PROJECT NO. 8.T500311
ORANGE COUNTY
STATION: 39+93.75 -Y6- REV. A1

SHEET 1 OF 3

OVERHEAD SIGN
ASSEMBLY
FOR SIGN #9

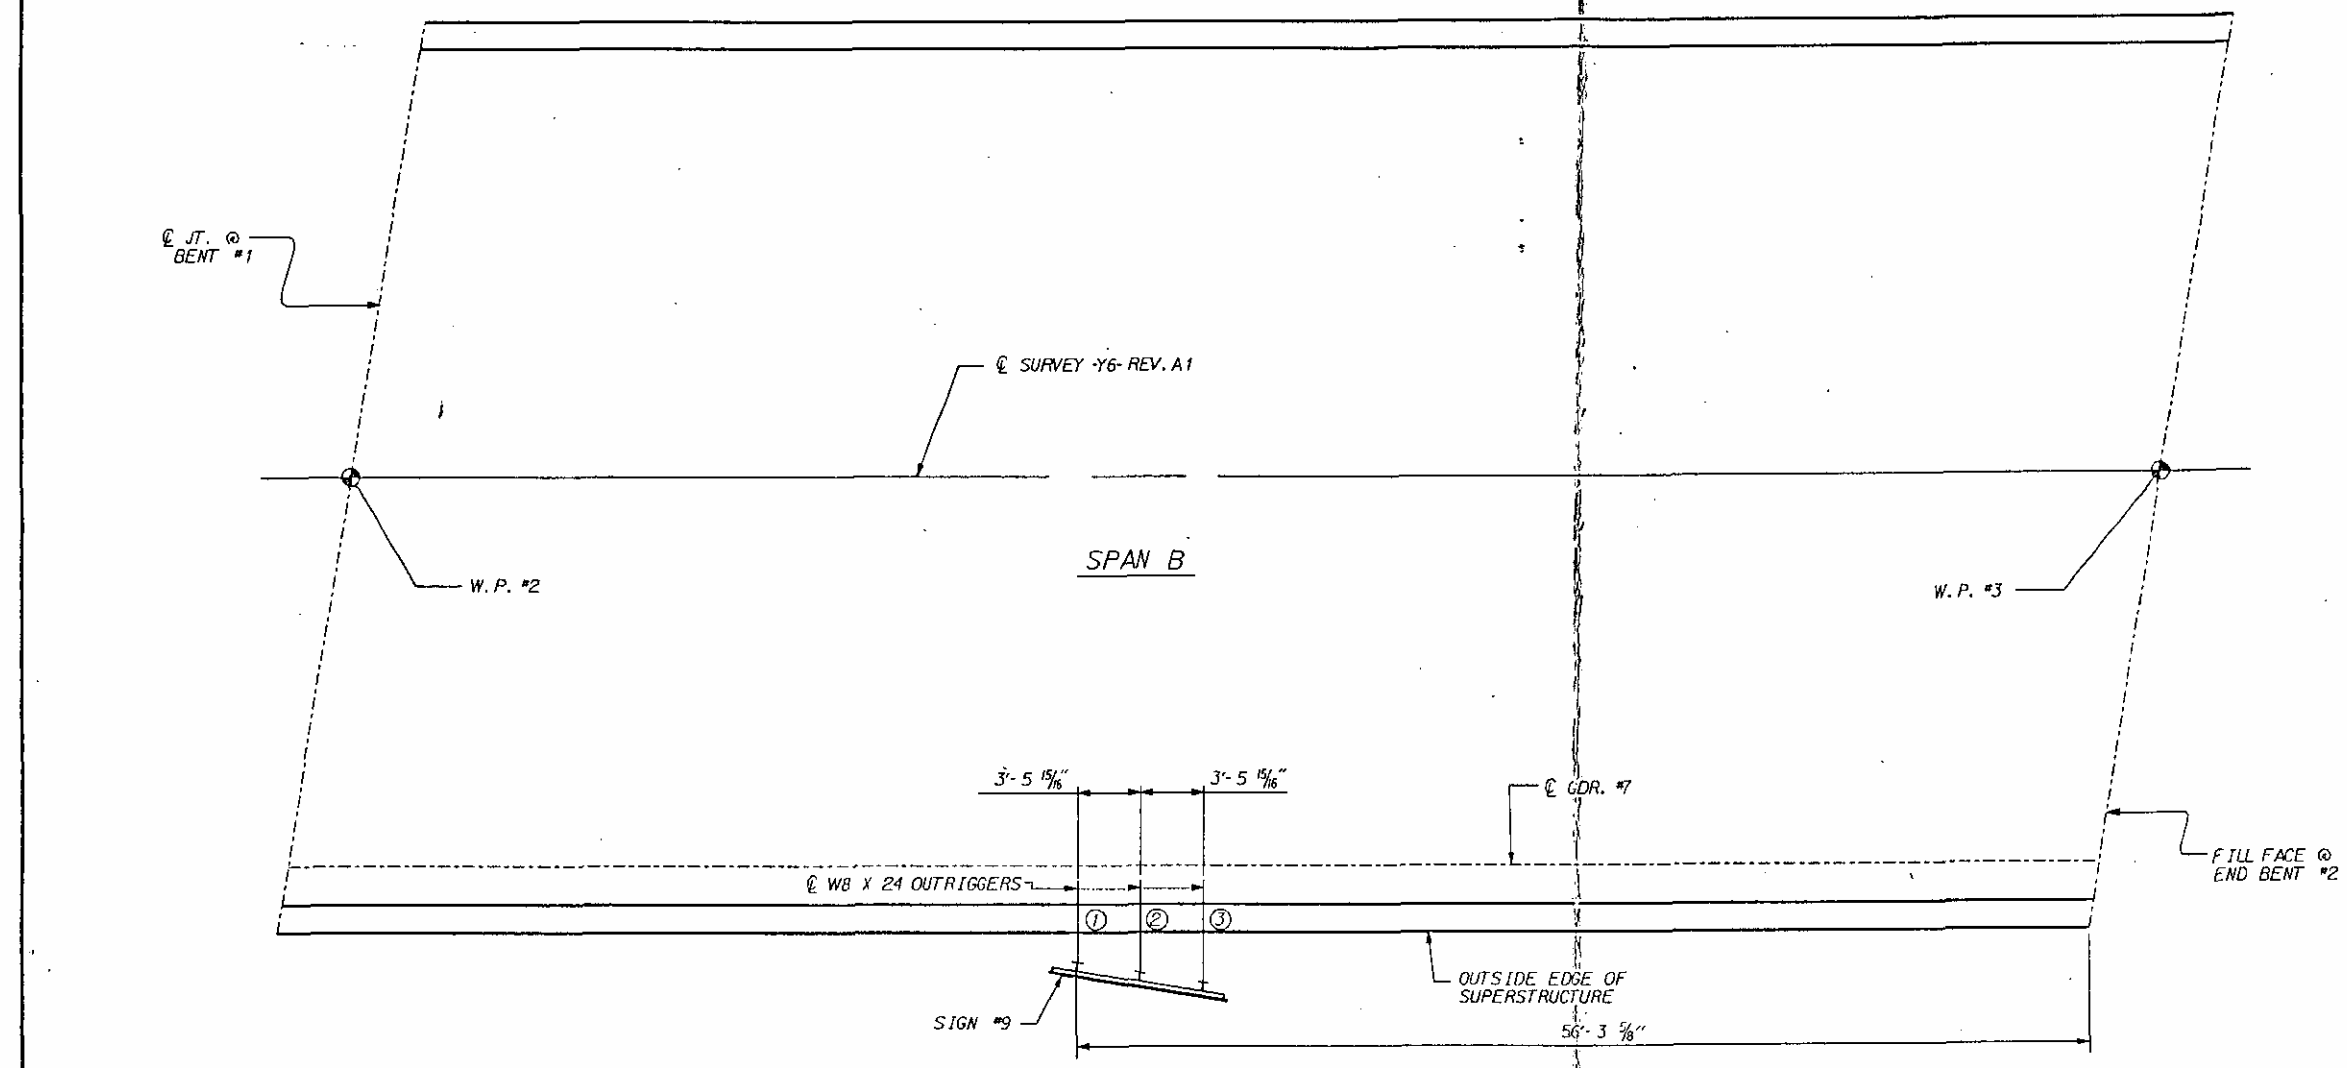
- 1 REV. #1 - DELETED NOTES #4 & #5 AND ADDED NOTE #12 BY: RST 3/31/94
✓ BY: TLC 3/31/94
- 2 REV. #2 - REVISED NOTE #12 TO ADDED DESIGN LOAD AND FIELD TESTING REQUIRED. BY: RST 3/7/95
✓ BY: TLC 3/7/95
- 3 REV. #3 - CHANGED LOCATION OF OVERHEAD SIGN ATTACHED TO BRIDGE. BY: RST 6/12/95
✓ BY: TLC 6/12/95

1 CONCRETE ANCHORS SHALL BE $\frac{3}{4}$ " NOMINAL DIAMETER STUD WITH A WASHER, LOCK WASHER AND NUT AND SHALL BE ADHESIVELY ANCHORED. SEE SPECIAL PROVISIONS FOR ADHESIVELY ANCHOR BOLTS OR DOWELS. THE YIELD LOAD OF THE $\frac{3}{4}$ " BOLT IS 12 KIPS. THE ANCHOR STUDS SHALL BE ASTM A36 AND GALVANIZED ACCORDING TO ASTM A153 OR SHALL BE STAINLESS STEEL. ANCHORS SHALL BE INSTALLED IN HOLES W/PROPER SIZE AS RECOMMENDED BY MANUFACTURER OF THE ANCHOR STUD. DESIGN LOAD IS 12 KIPS. FIELD TESTING IS REQUIRED. SEE SPECIAL PROVISIONS FOR ADHESIVELY ANCHOR BOLTS OR DOWELS.

PROJECT NO. 8.T500311
ORANGE COUNTY
STATION: 39+93.75 -Y6- REV. A1
SHEET 2 OF 3

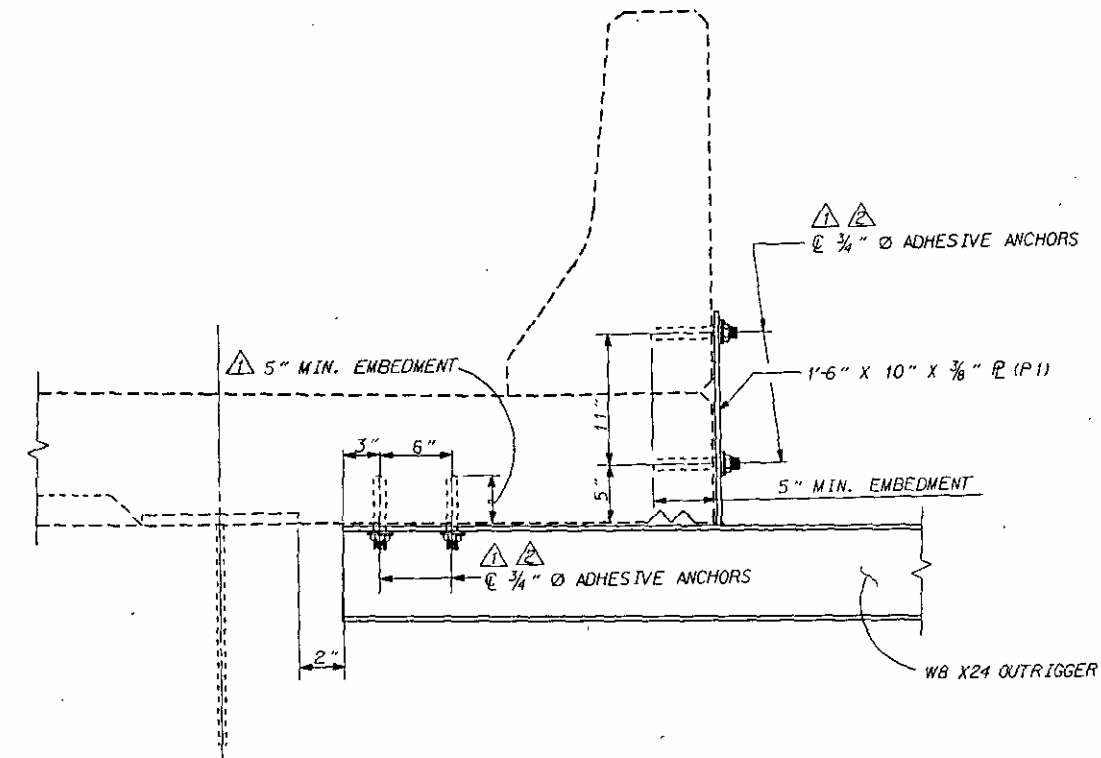
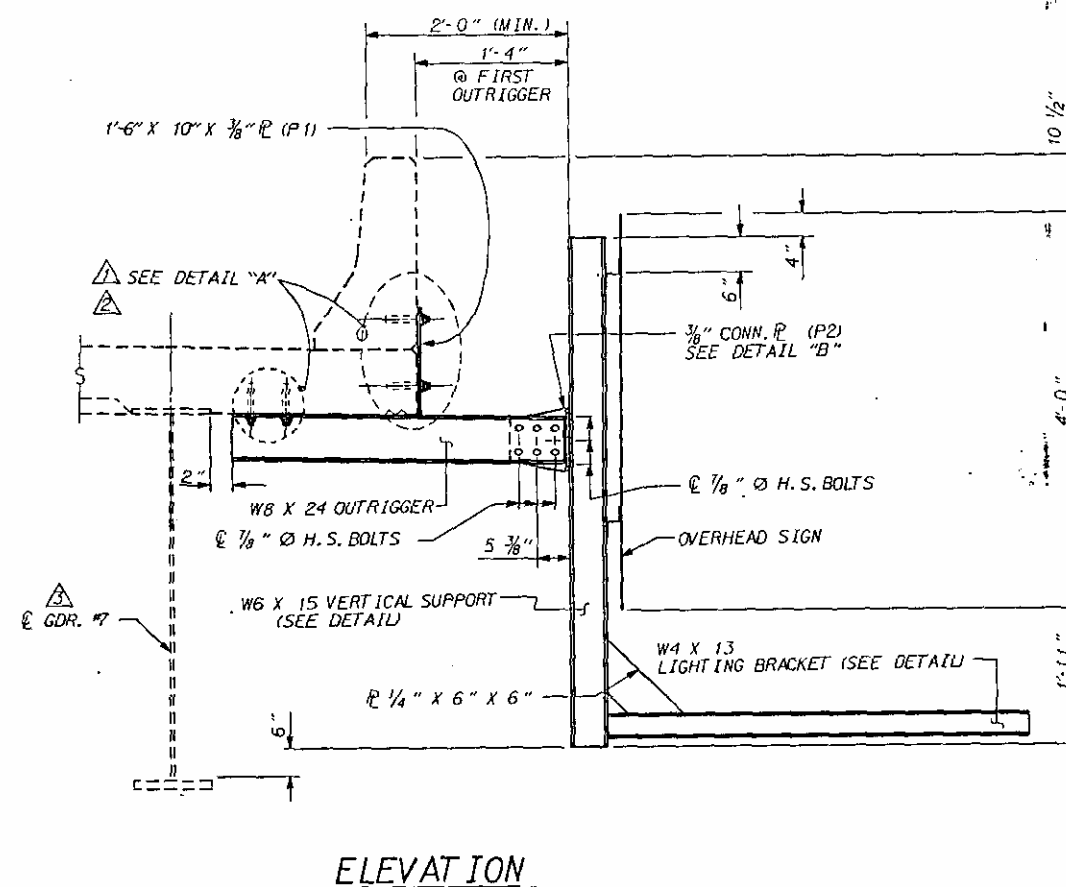
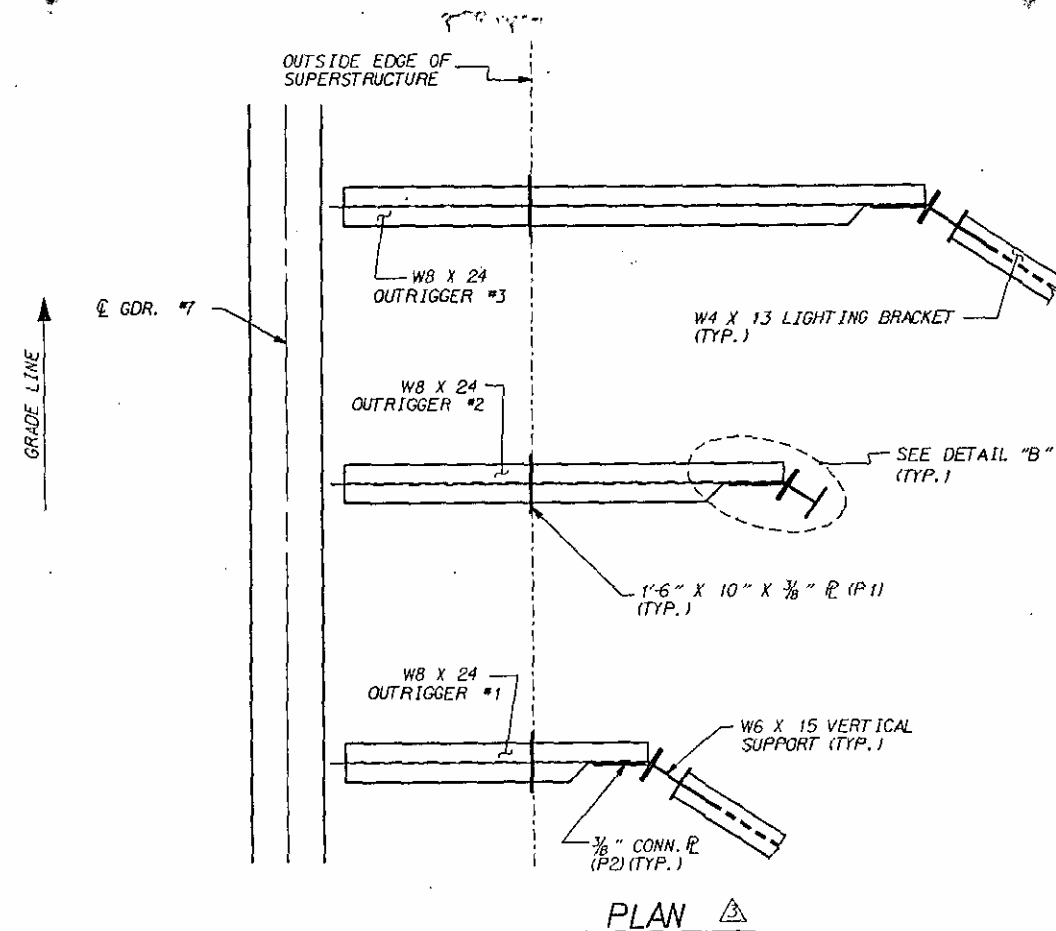
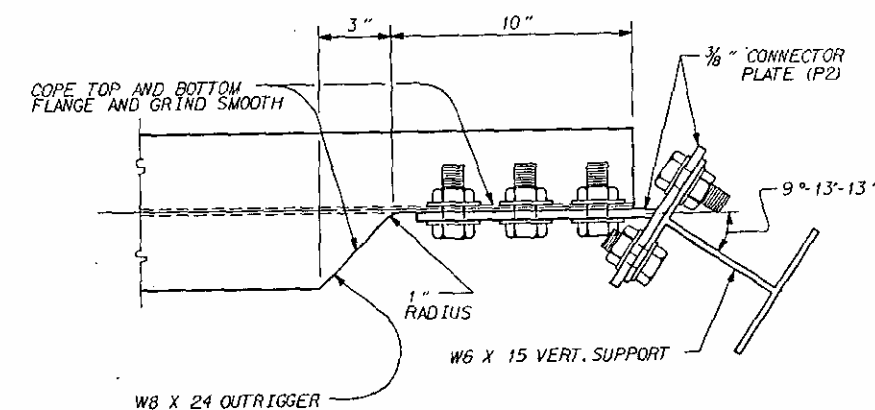
- REV. #1 - CHANGED EMBEDMENT DEPTH FROM 3 1/2" TO 5". IN THE BOTTOM OF OVERHANG, AND CHANGED EXPANSION ANCHOR TO ADHESIVE ANCHOR. BY: RST 3/31/94 ✓ BY: TLC 3/31/94
- REV. #2 - CHANGED ADHESIVE ANCHORS FROM BOLT TO STUD WITH WASHER, LOCK WASHER AND NUT. BY: RST 3/7/95 ✓ BY: TLC 3/7/95
- REV. #3 - CHANGED LOCATION OF OVERHEAD SIGN ATTACHED TO BRIDGE. BY: RST 6/12/95 ✓ BY: TLC 6/12/95
